REF: 20170929

Technical buletin N° 3 : Clutch lock washer EC 250/300 2018

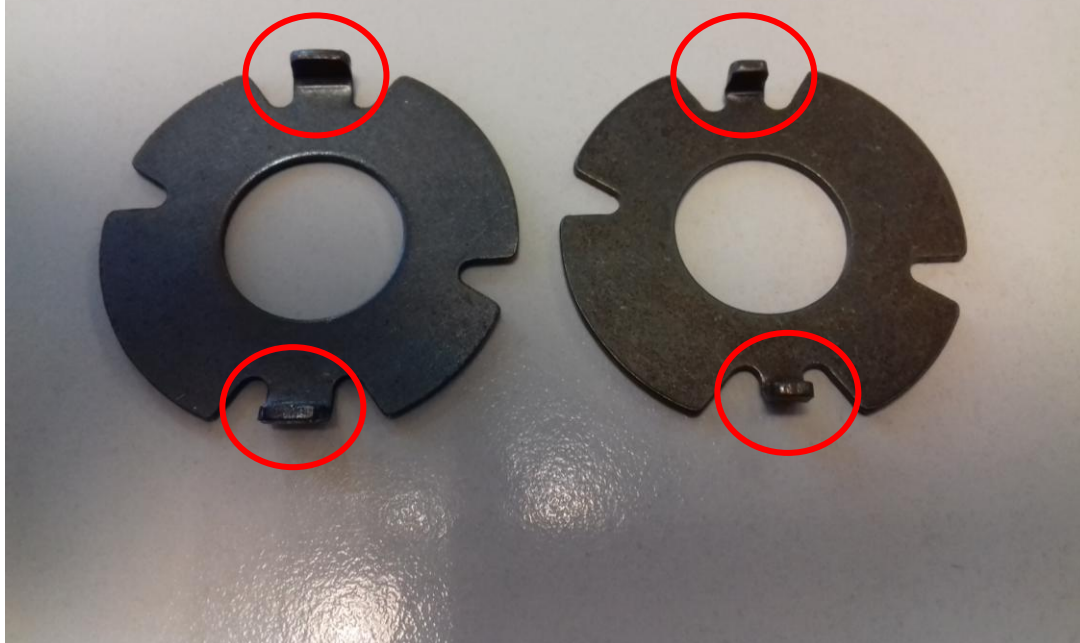
We inform you that have been applied a modification in the clutch lock WASHER fitted in the EC 250/300 2018.

The new washer **ME21120GG-CLJ-1** has the two slimmer nails to be better fitment in the new clutch basket of the 2018 YM.

This modification has been implemented to the following V.I.N.

EC 250 : **VTR4E2500J0970197**

EC 300 : **VTR4E3000J0970954**

Therefore, is necessary to replace with the new clutch lock WASHER during any clutch maintenance-repair.

Previous **ME25632022**
For models until 2018 YM
EC 250/300 2017

New **ME21120GG-CLJ-1**
For 2018 YM EC 250/300 2018
